Docket Item # 2 & 3
BAR CASE # 2014-0378 &
2014-0379

BAR Meeting
March 18, 2015

ISSUE: Partial Demolition/Capsulation and Addition

LOCATION: 214 South Alfred Street

SHEET NUMBER
A-2

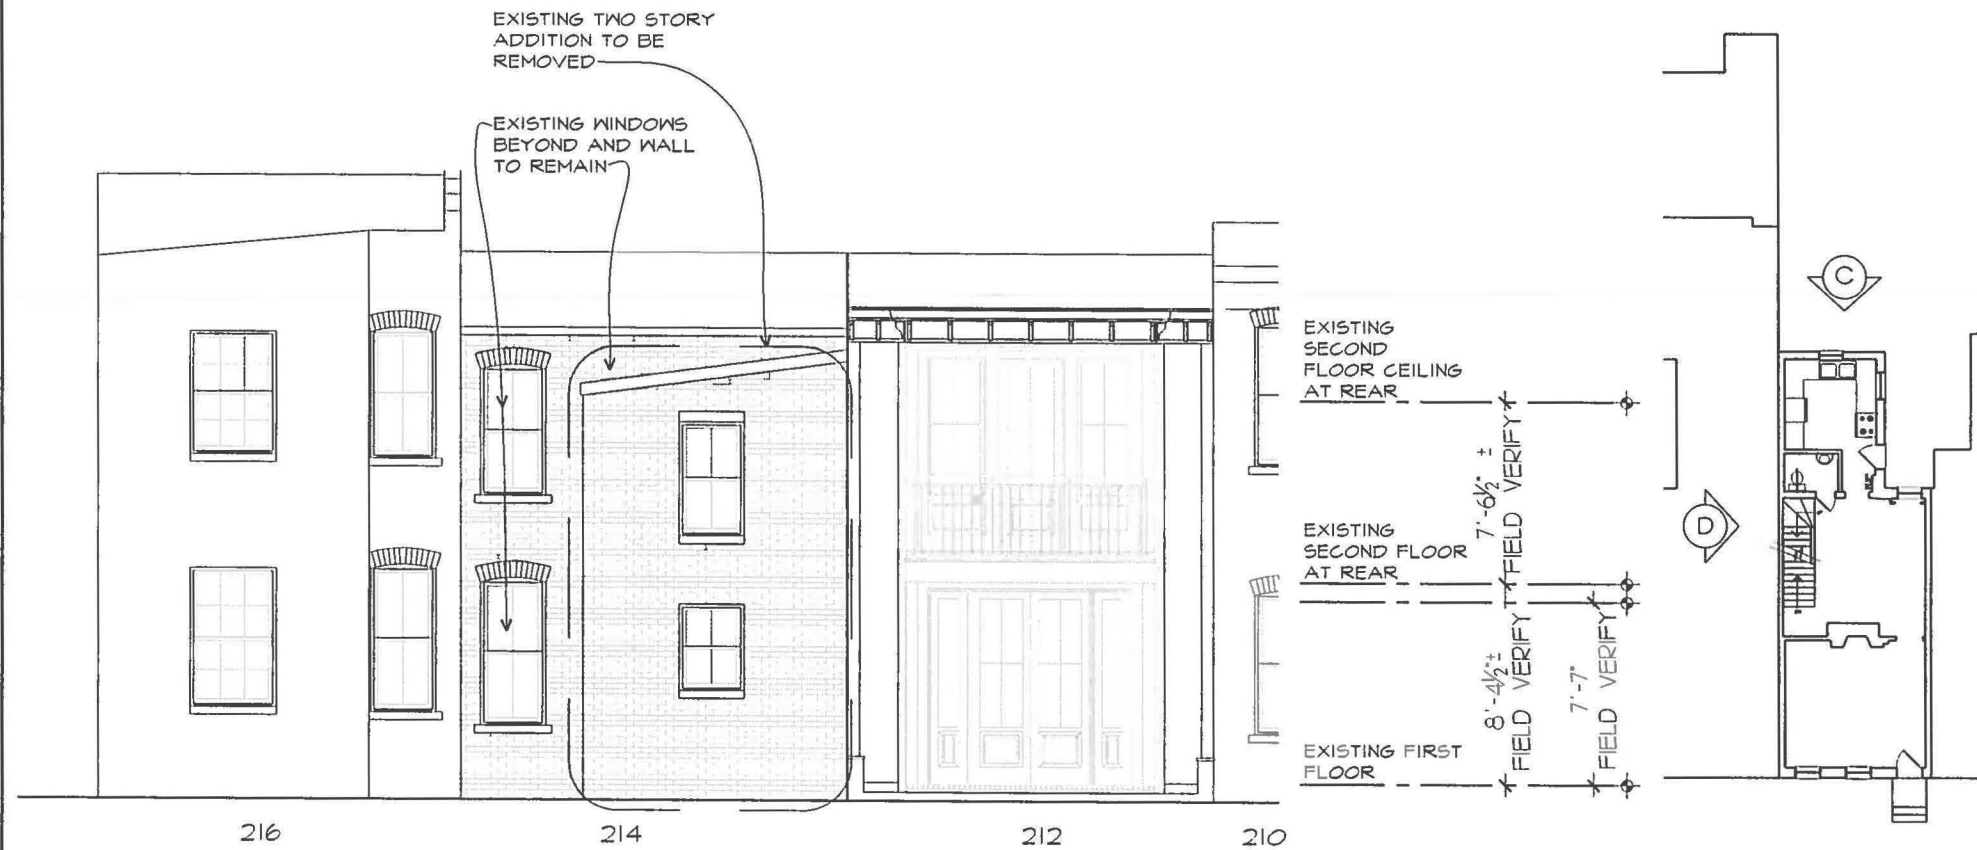
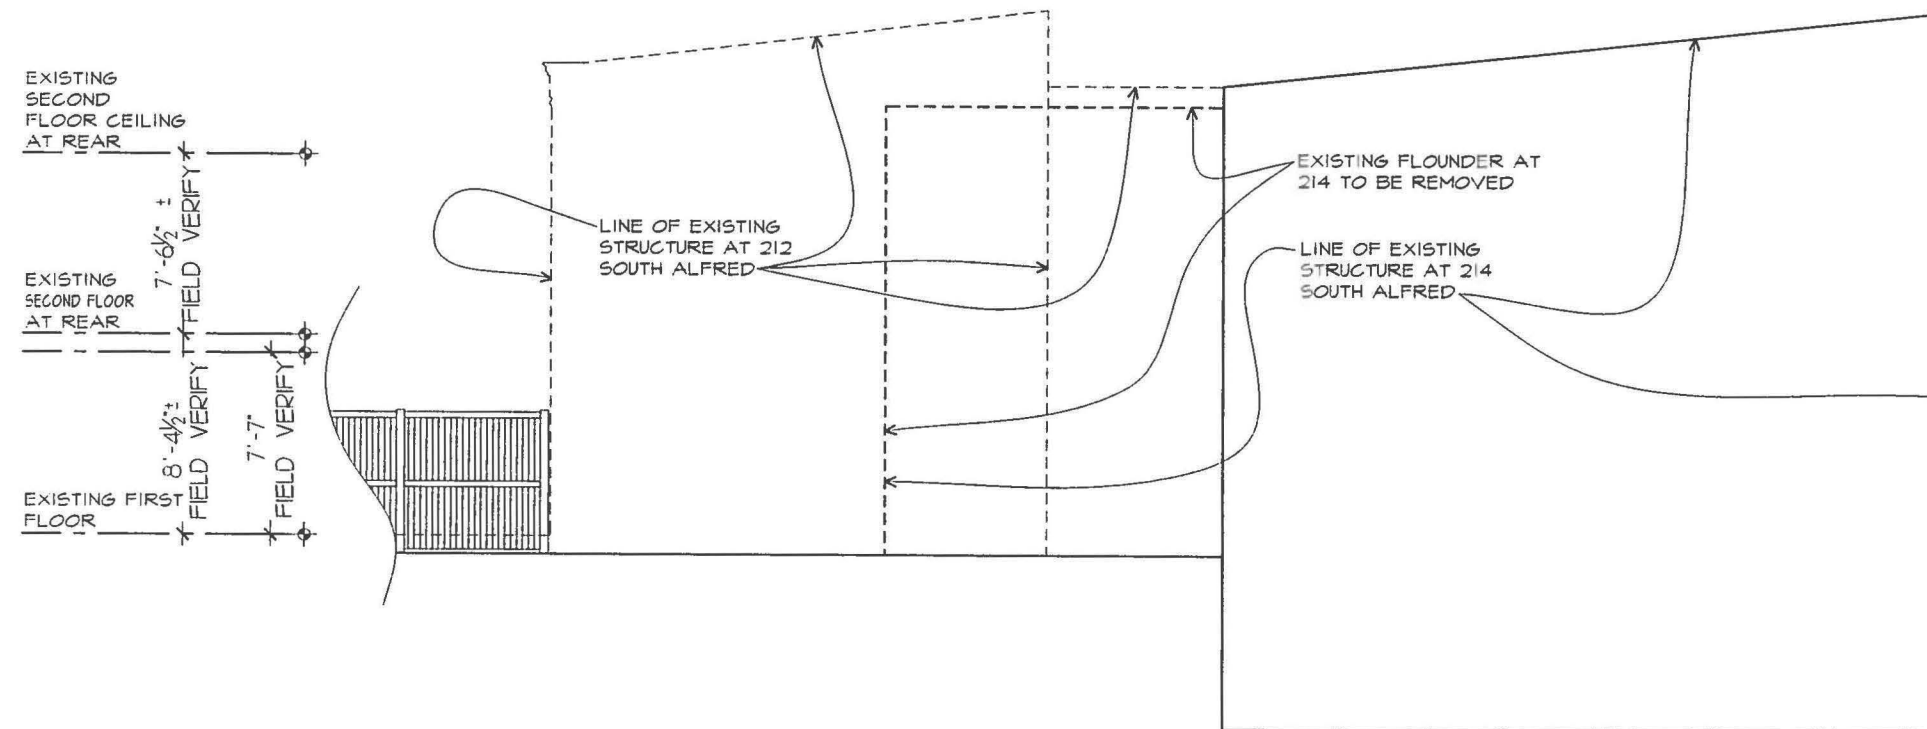
In the present case, staff recommends that the applicant retain and preserve, at a minimum, the south wall and significant portions of the roof. Staff supports some demolition and capsulation of the previously altered east wall of the ell and supports a scheme that would result in three distinct components: the historic main block, the historic rear ell, and the new addition, as was approved at the subject property's twin, next door at 212 S Alfred Street, 418 S Pitt Street, and numerous other cases for rear additions.

However, while staff recommends that the applicant maintain the proposed design direction for the addition, staff recommends that the Board defer the case for restudy and request an addition that will require significantly less demolition of the exterior walls and roof of the existing ell.

1. At a minimum, the south wall and significant portions of the roof of the ell be retained, and;
2. The main block, ell, and proposed addition read as three distinct components to illustrate the evolution of the property.
